From: [REDACTED]
Sent: Thursday, 4 February 2021 6:04 PM
To: Macedon Ranges Shire Council
Subject: PLN/2019/572 & PPLN/2019/571

**RE: Objection to Notice of an Application for Planning Permits
 PLN/2019/571 & PLN/2019/572
 Lot 1 PS 331532TP P/Carlsruhe
 Edgecombe Road, Kyneton**

Objection to Planning Application PLN/2019/572 and PLN/2019/571

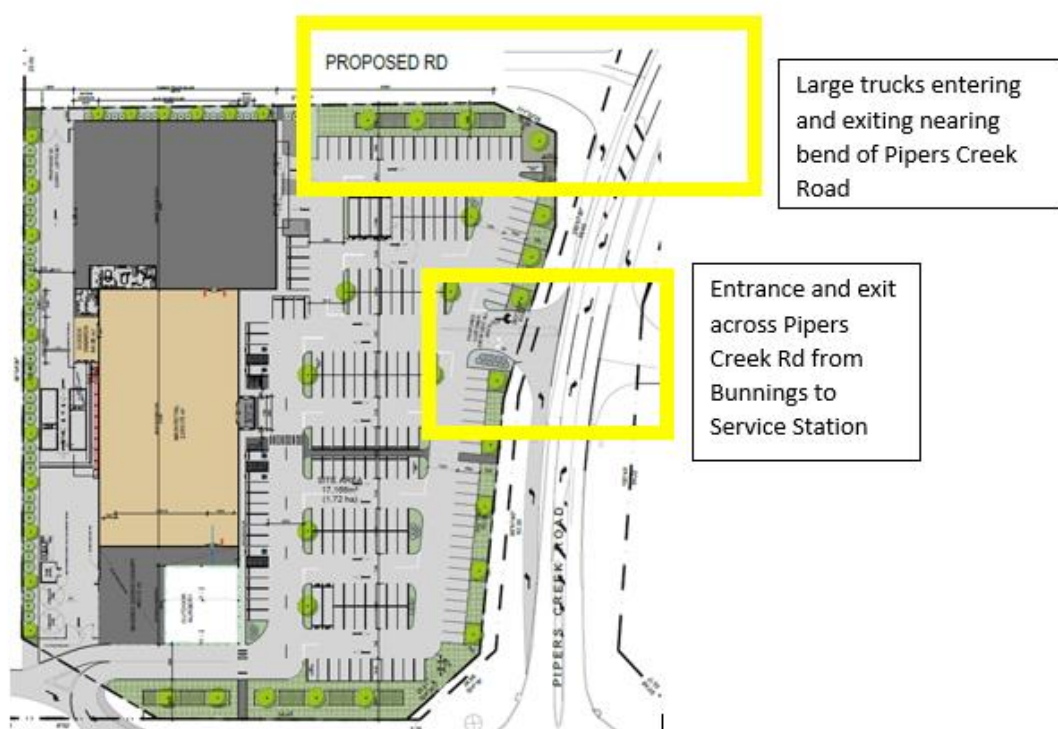
The traffic assessments were also done prior to the two businesses now located across from the proposed service station site, vehicles are already crossing over the double lines and right-hand traffic lane for Pipers Creek Road to access these driveways instead of using the Saleyards Road driveway. Assessments were also not undertaken during the busier warmer months of the year and over long weekends. I believe future traffic counts may have been underestimated for the attendance to both of these sites.

Once these businesses are built and the road interfaces created, they will not be able to be changed to accommodate further increased traffic and will therefore impact the current residents who utilise these roads to access the township, work and schools.

there has been a significant increase to the traffic in this area over the last 10 years with not only large trucks but also with caravans and boats as the main roadway to Lake Eppalock and the Murray River. This is likely to continue with Metropolitan Melbourne residents now frequenting regional Victoria more often.

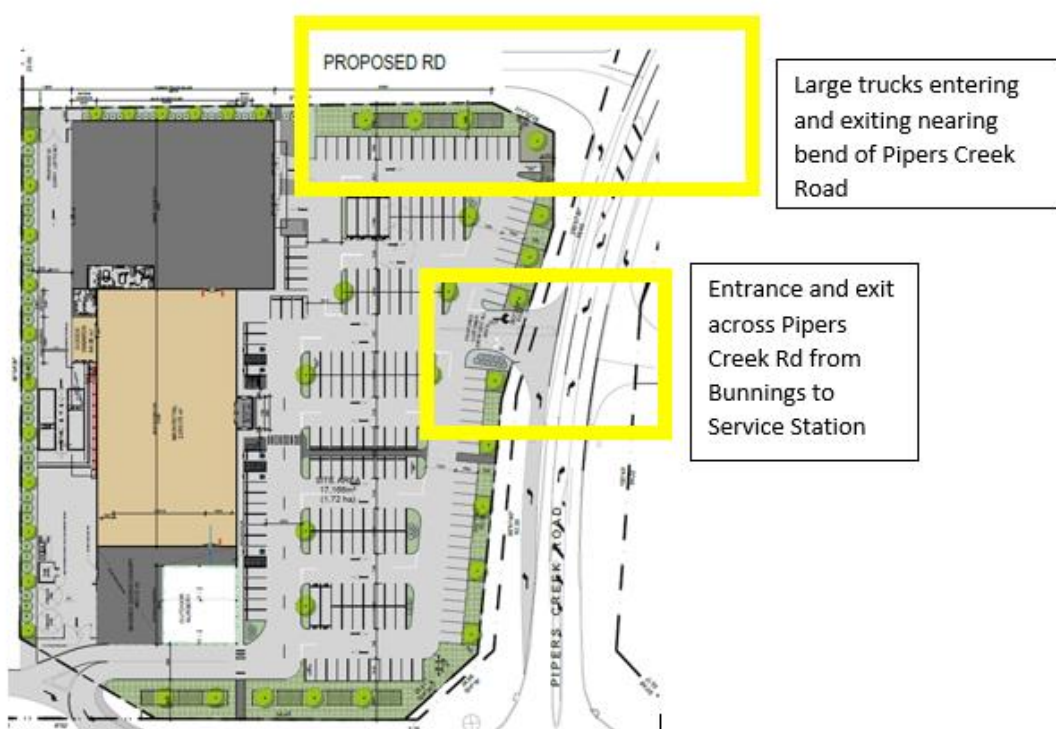
The traffic assessments were also done prior to the two businesses now located across from the proposed service station site, vehicles are already crossing over the double lines and right-hand traffic lane for Pipers Creek Road to access these driveways instead of using the Saleyards Road driveway. Assessments were also not undertaken during the busier warmer months of the year and over long weekends. I believe future traffic counts may have been underestimated for the attendance to both of these sites.

Once these businesses are built and the road interfaces created, they will not be able to be changed to accommodate further increased traffic and will therefore impact the current residents who utilise these roads to access the township, work and schools.

there has been a significant increase to the traffic in this area over the last 10 years with not only large trucks but also with caravans and boats as the main roadway to Lake Eppalock and the Murray River. This is likely to continue with Metropolitan Melbourne residents now frequenting regional Victoria more often.
